LTB01086NAS1

TECHNICAL BULLETIN

501-14: Handles, Locks, Latches and Entry Systems

Keyless Entry System Lock Function May Not Operate and/or Operates Intermittently

E211812

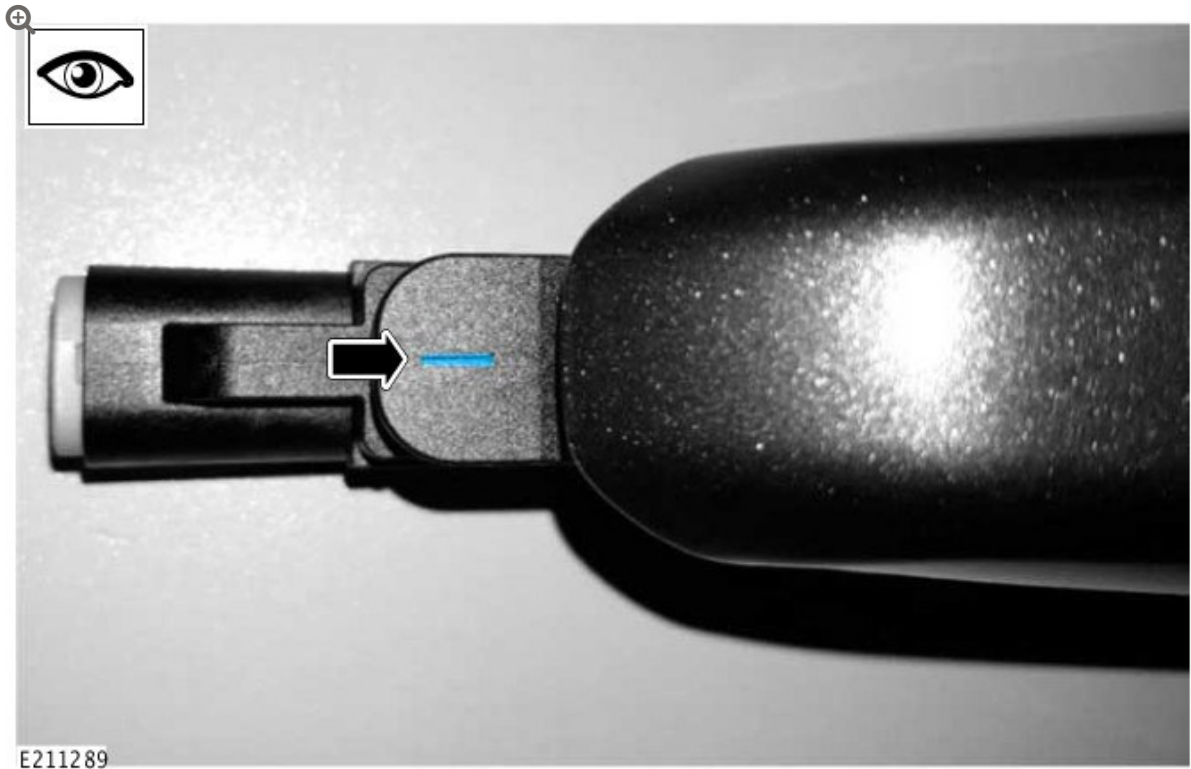
This may be caused by water ingress into the exterior door handles preventing correct operation of the keyless entry lock function.

Refer to the illustration for the different handle types to make sure the correct replacement handle(s) is ordered for the vehicle.

- 1 'dimple' type handle (LR061200)
- 2 'stripe' type handle (LR040667)
- 3 'chrome' type handle (supplied by color)

Inspect the new door exterior handle(s) for the identification mark.

Replace the defective front exterior door handle(s) (see TOPIx Workshop Manual section 501-14: Exterior Front Door Handle).

Replace the defective rear exterior door handle(s) (see TOPIx Workshop Manual section 501-14: Exterior Rear Door Handle).
